Product-Change Notice P2021-10

TSSE 310 S

from September 2021 production

Details (left photo: old version, right photo: new version):

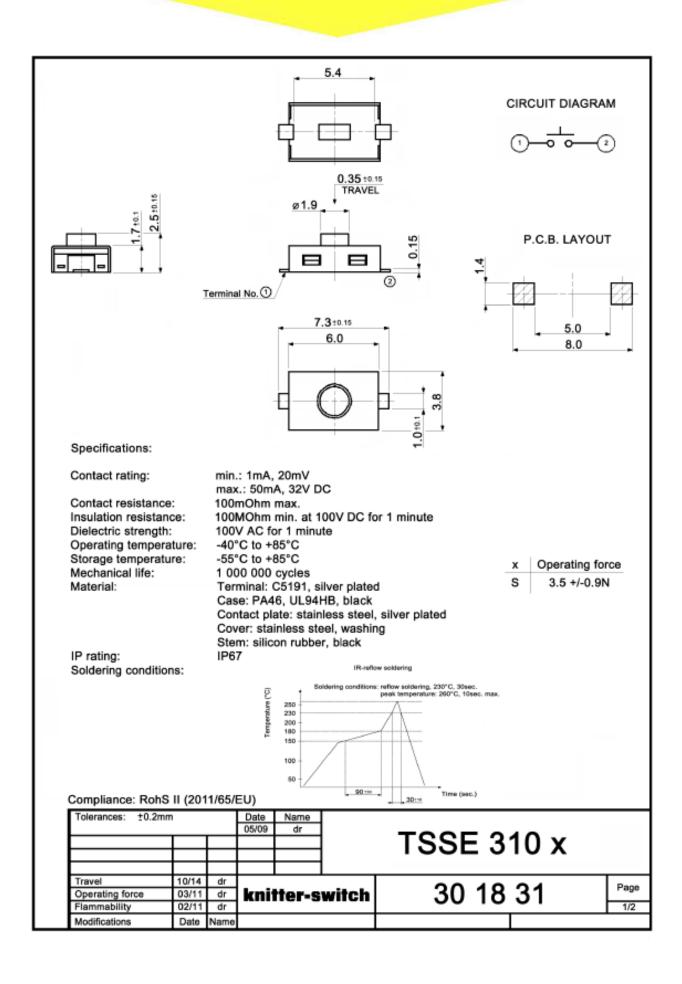
In course of new mold introduction caused by irreparable damage of cavities after 14 years the switch design was slightly revised.

Inside: Fixed contact is optimized in order to achieve better contact.

Plastic resin is changed from PA46 to PPA (lower humidity absorption rate)

Bottom side: the revised products come with easily readable mold numbering
